Case File Number: PLN20124

Location:	1431 Franklin Street
Assessor's Parcel Number(s):	008 062100807
Proposal:	Major Conditional Use Permit and Regular Design Review to construct a 27-story (425-foot tall) 419,480 square feet office tower with a parking garage above grade.
Applicant:	TC II 1431 Franklin, LLC
Contact Person/ Phone Number:	Kyle Winkler, Tidewater Capital/(510) 290-9901
Owner:	TC II 1431 Franklin, LLC
Case File Number:	PLN20124
Planning Permits Required:	Major Conditional Use Permit for large scale development; Regular Design Review
General Plan:	Central Business District
Zoning:	CBD-P Central Business District Pedestrian Retail Commercial Zone Height Area 7, no limit
Environmental Determination:	Determination Pending, Environmental analysis to be conducted prior to any discretionary action
Historic Status:	Project site is located within an existing listed National Register historic resource, the Downtown Historic District Area of Primary Importance (API).

Office Entitlement - Response to Design Review Analysis
11/09/2021

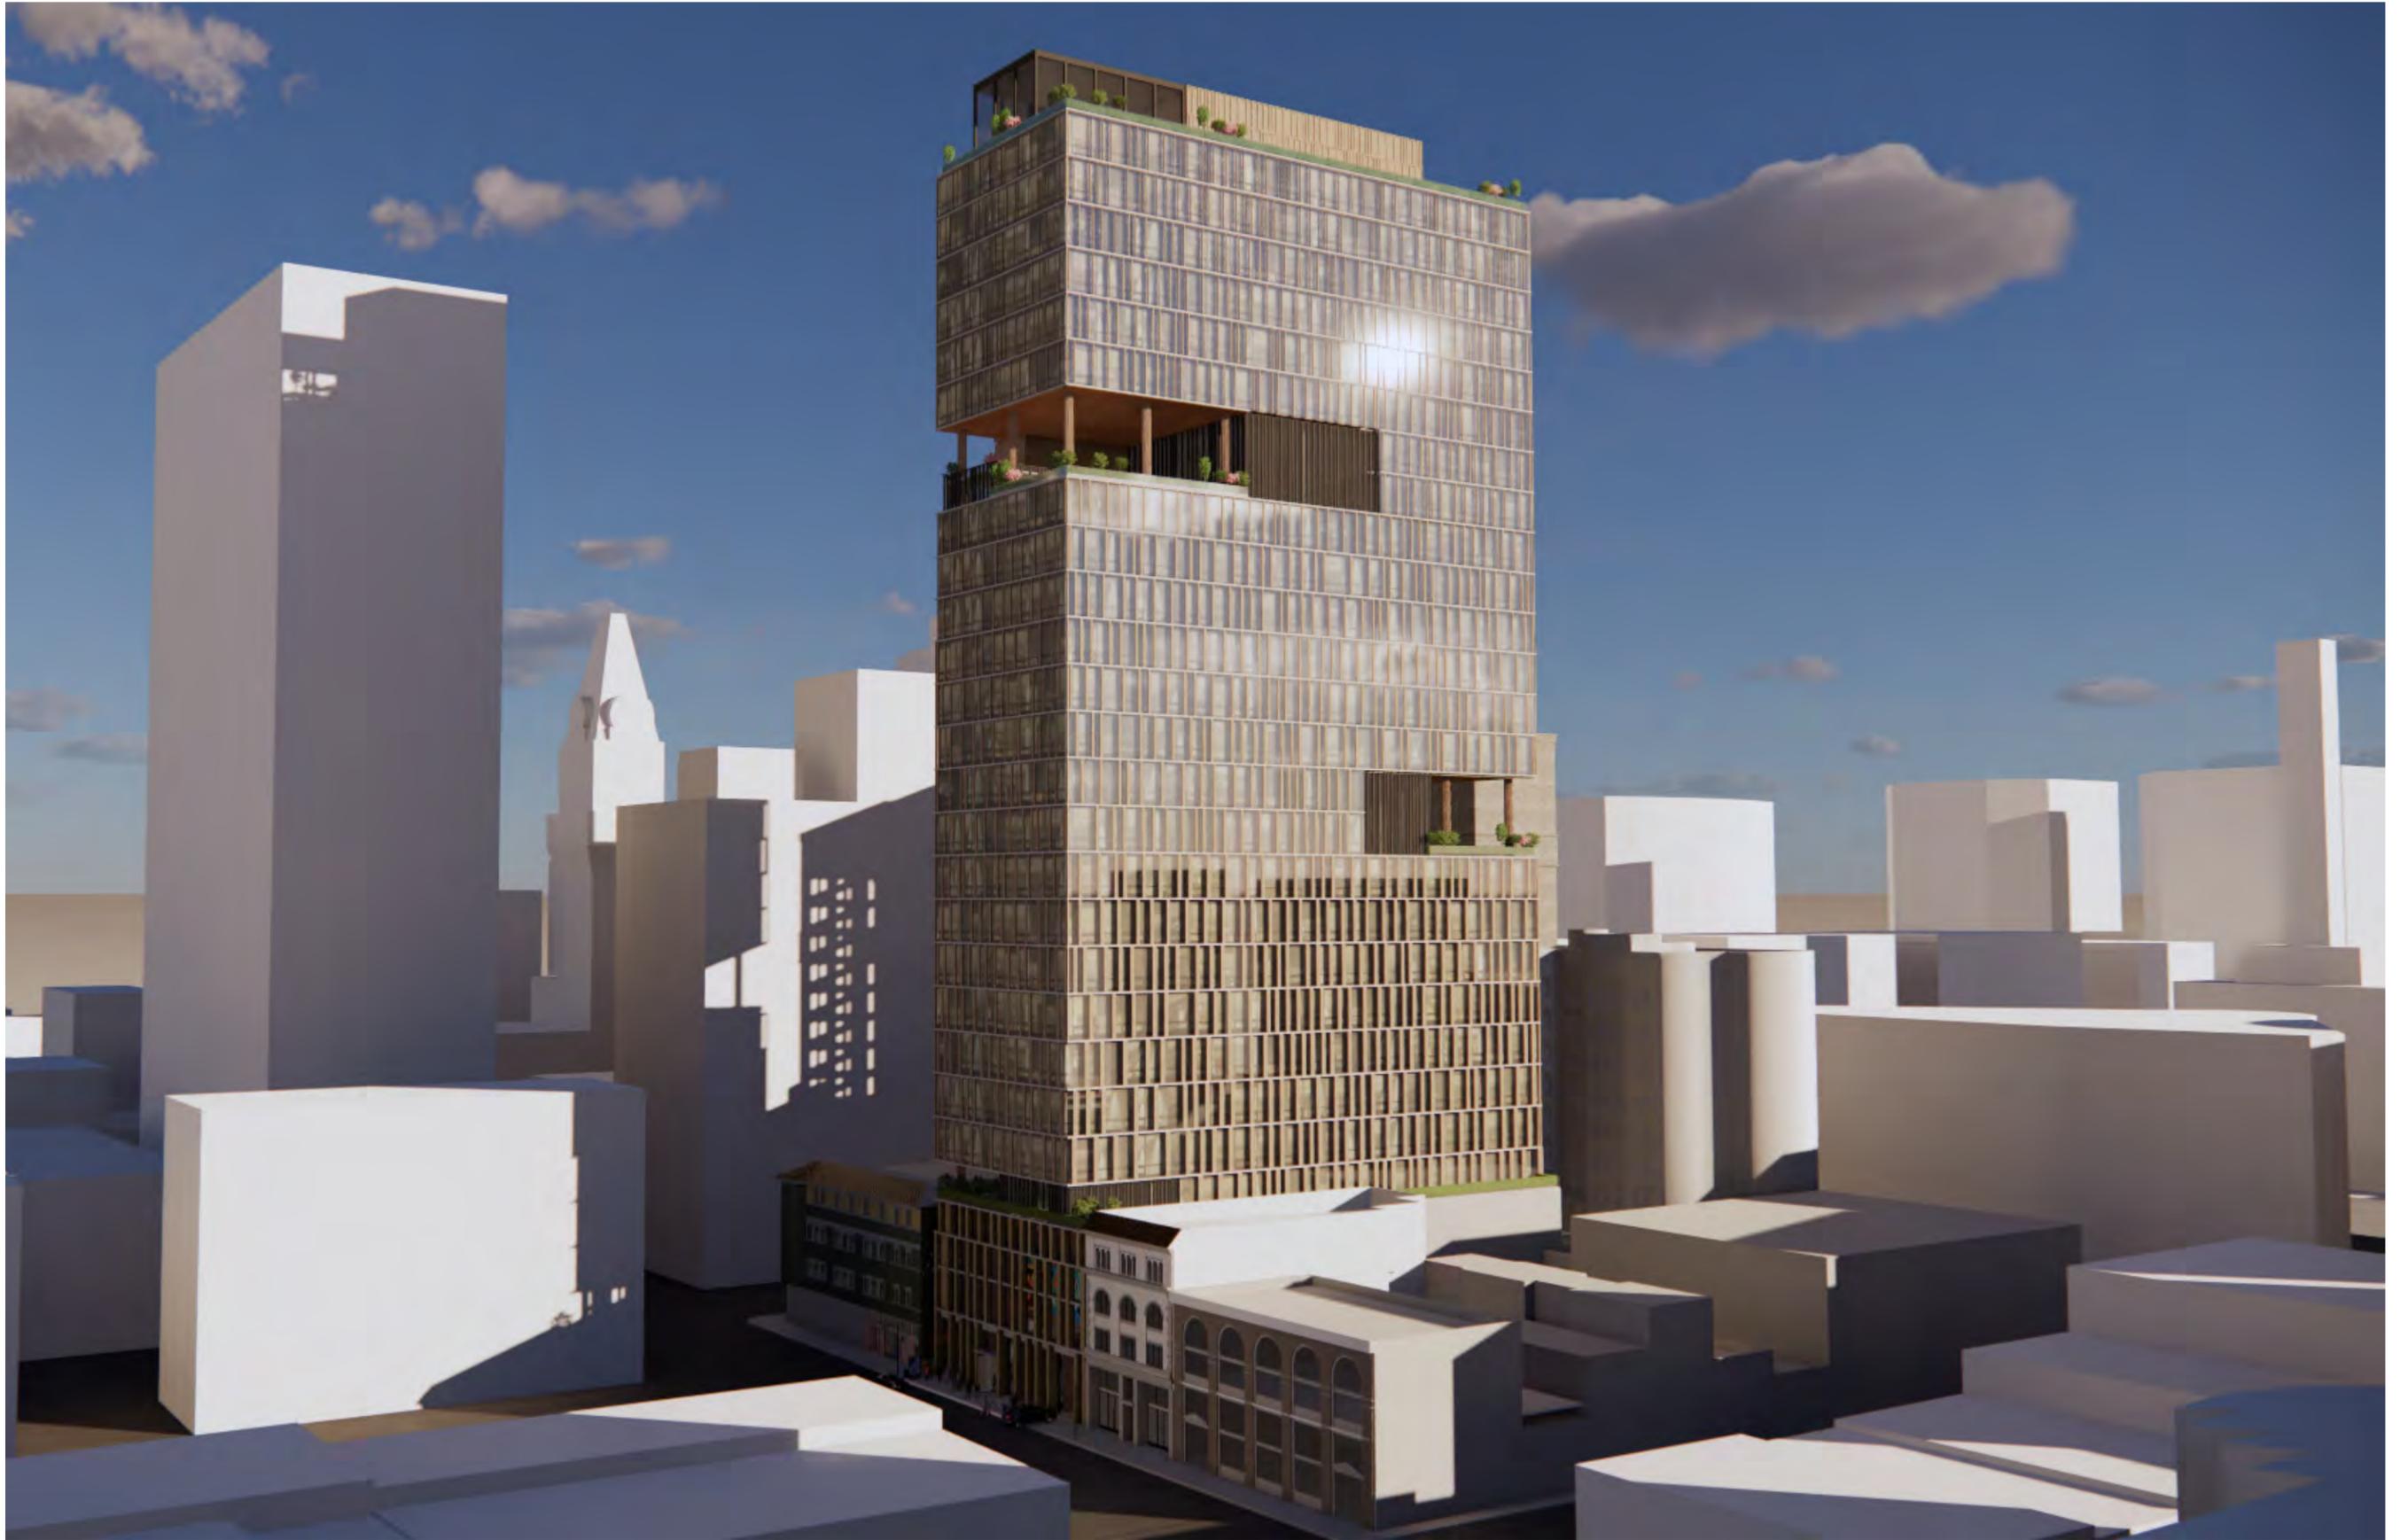
The proposal is not clear on how it tries to relate to the API district or how it will result in a building with visual quality, craftsmanship, high quality and durable materials that are at least equal to that of the API contributors

The base of the building has been redesigned to better reflect the widths and rhythm of the facades on the street, and entrances that reflect the patterns on the street. As previously noted, the revised design of the proposed building has a strong relationship to the adjacent buildings in terms of massing and, it's modern interpretation to the predominately classical horizontal layer that exists in the Historic district. The pattern of windows also mimics the window layout of the adjacent buildings in a modern way. In addition, the base of the proposed building will have a traditional brick base to pick up on the similar use of materials that are prevalent on the adjacent buildings in the Historic District. In addition, we have located key cornice lines to match the adjacent buildings. But it is worth noting that the cornice lines of the two adjacent buildings are not at the same height or size. With this in mind, we elected to split the difference and make for a compromise geometry that is intended to be visually as cohesive as possible. Most importantly the building matches the character-defining height of the API at the base with the building setting back above at the very prominent cornice line.
